## STRUTHERS RANCH SUBDIVISION, FILING NO. 5

### DRAINAGE LETTER REPORT

October 26, 2020  
Project No. 20-288

**FIGURE 6 – FIRM FIRMETTE FOR COMMUNITY PANEL 08041C0287G**

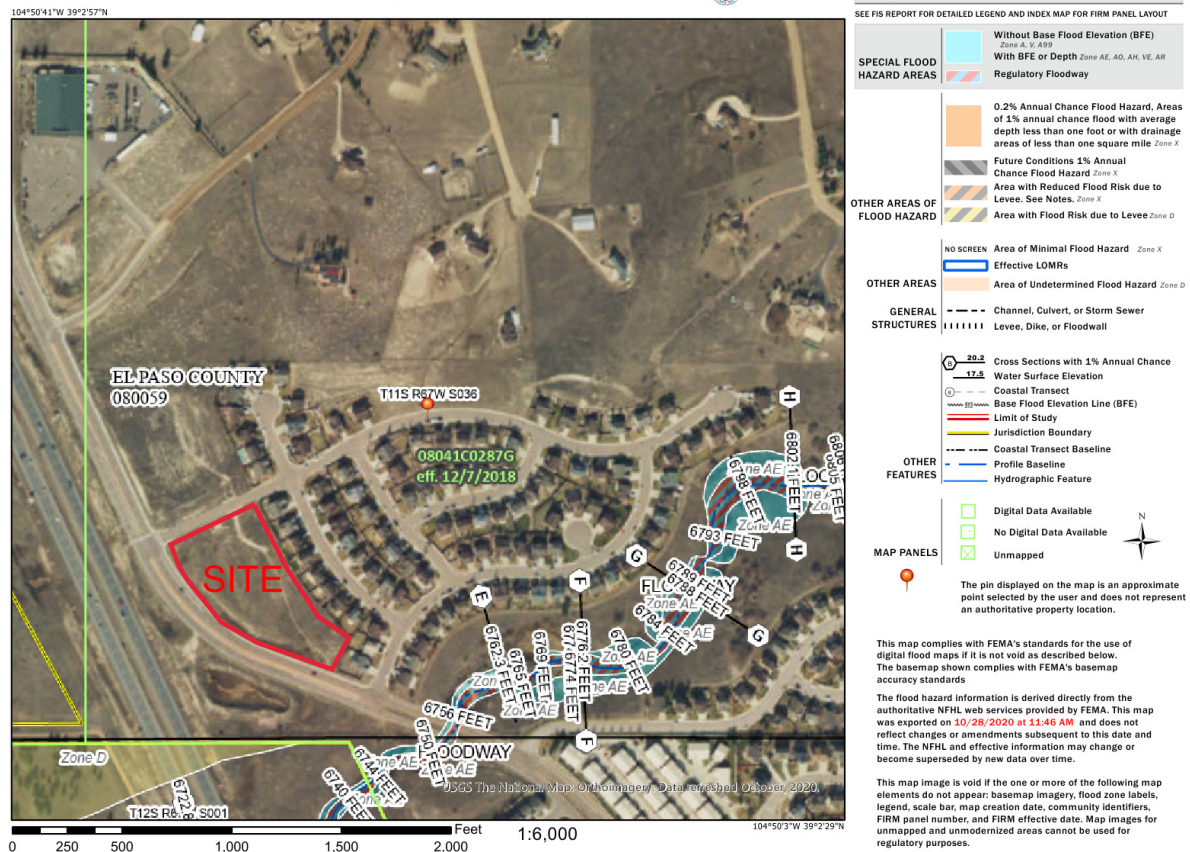
Please update panel revision date to 12/7/2018.

Inlet ID: **Inlet DP 2**

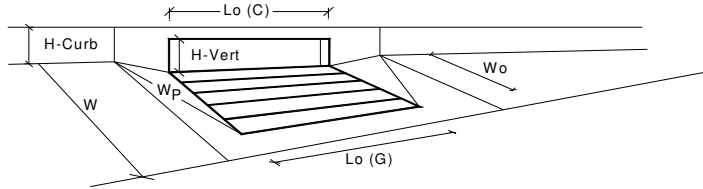
According to developed conditions drainage map, proposed grate is type 16 inlet. Please update to remove inconsistencies.

Per developed conditions drainage map, design point 2 flows do not match. Please update to remove inconsistencies.

Inlet ID: **Inlet DP 6**

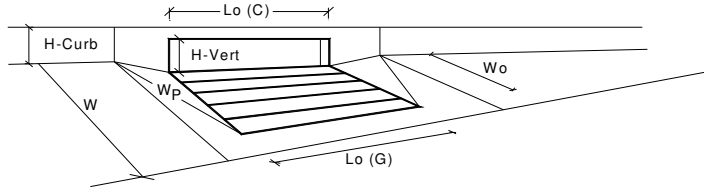
Per developed conditions  
drainage map, design point  
6 flows do not match. Please  
update to remove  
inconsistencies.

### Table 6-2. Rainfall Depths

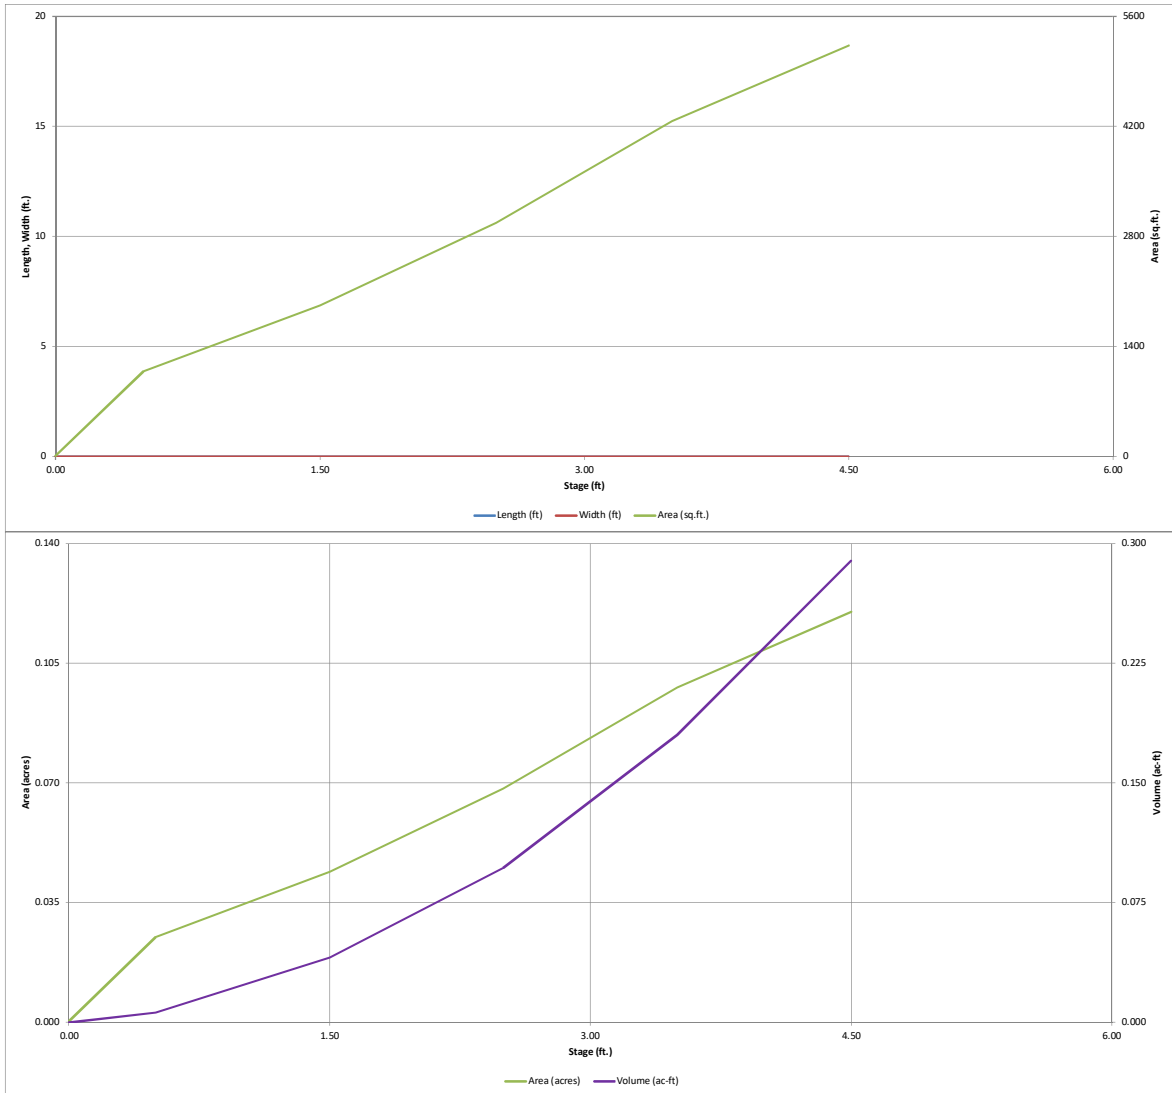
Remove the user override for WQCV. This shall be sized per the watershed area

Revise the 2yr through 100yr storm runoff volume per City DCM Table 6-2.

STRUTHERS RANCH  
SUBDIVISION FILING NO. 5  
FINAL DRAINAGE  
PLAN

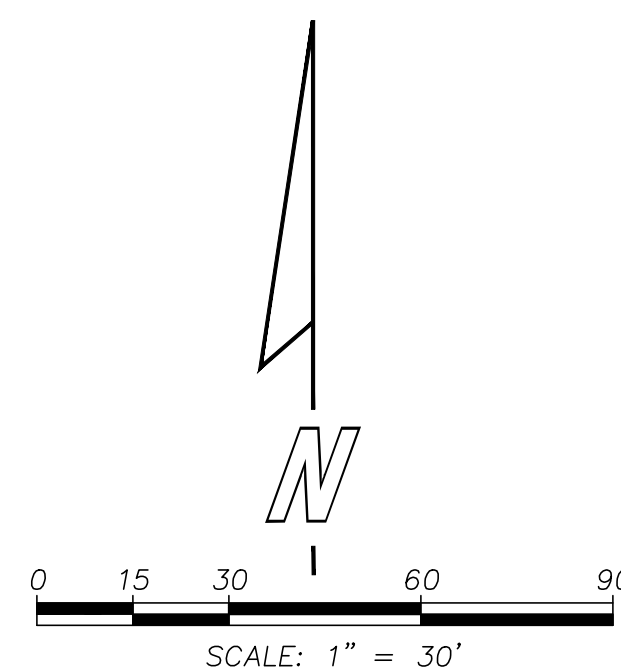
Remove the access from Struthers Road. No direct lot access is allowed from Struthers Road
